ALL SAINTS FOOD WAREHOUSE

COVER
CONDITIONAL USE PERMIT SET

SITE DEVELOPMENT

ALLEY WAY PLAN

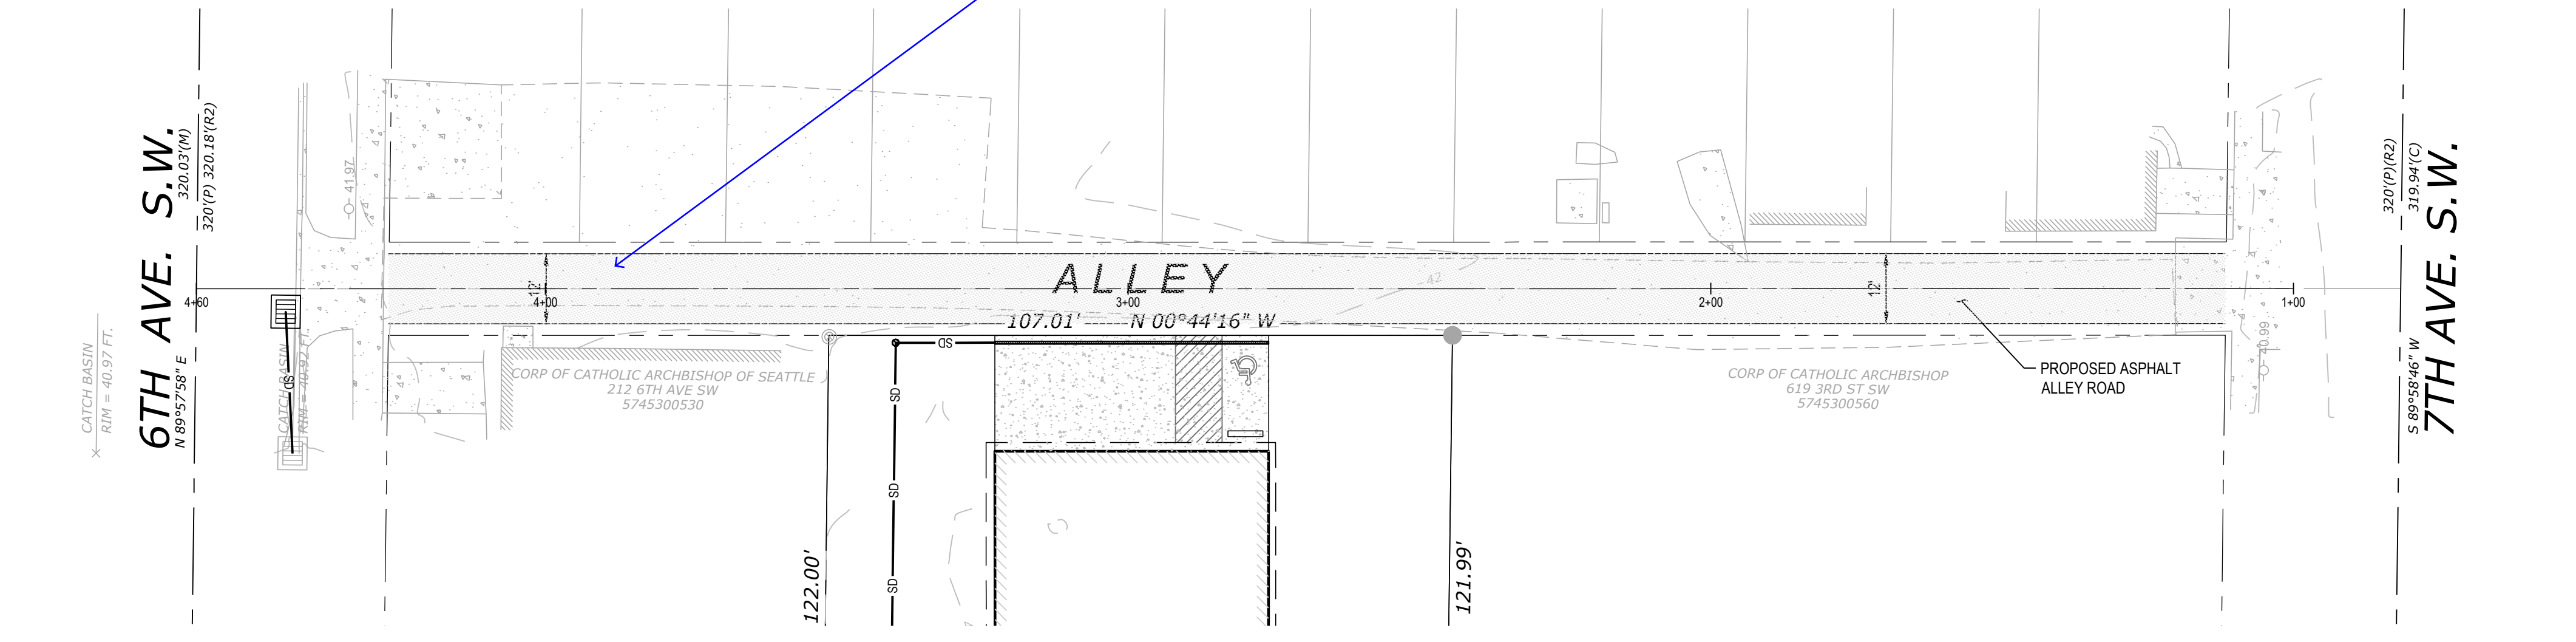
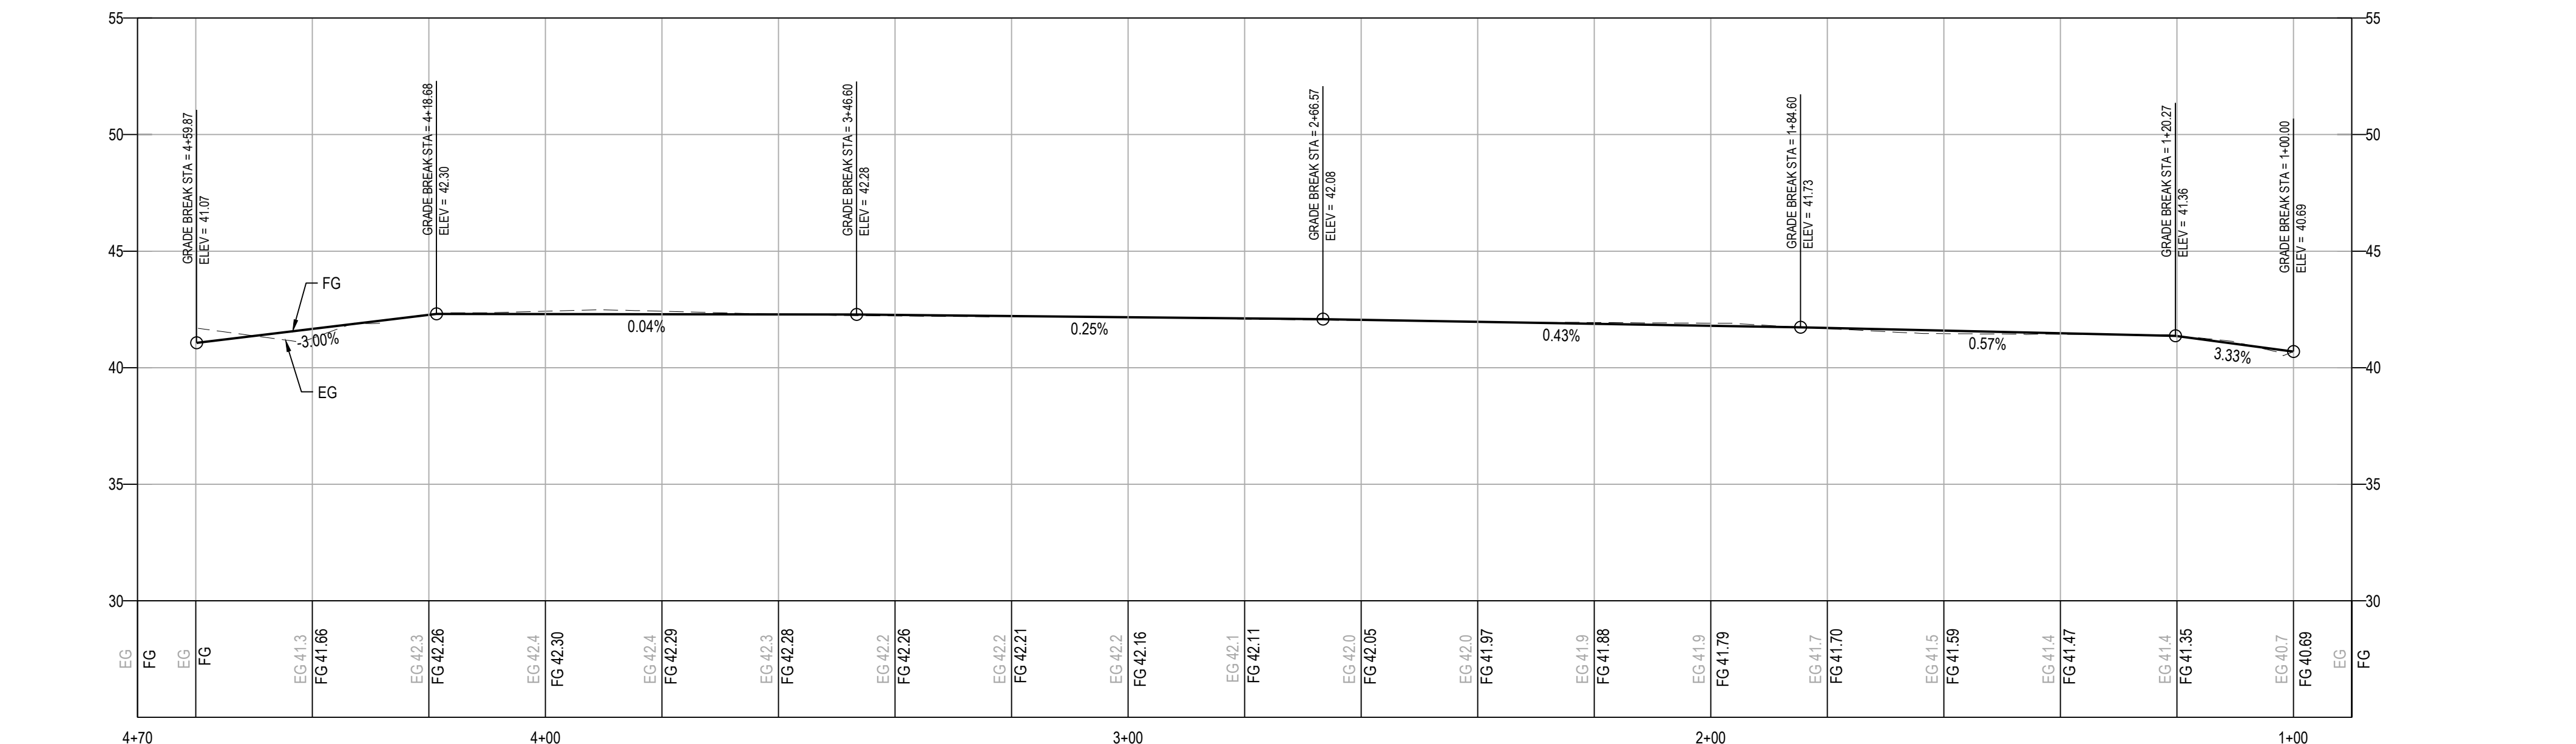
More information is required for the paving of the alley. Hard surface square footage needs to be included in the TDA for the project. Also, Geotech report indicates that infiltration is infeasible on your adjacent site. Clarify the design of the permeable alley in this context.
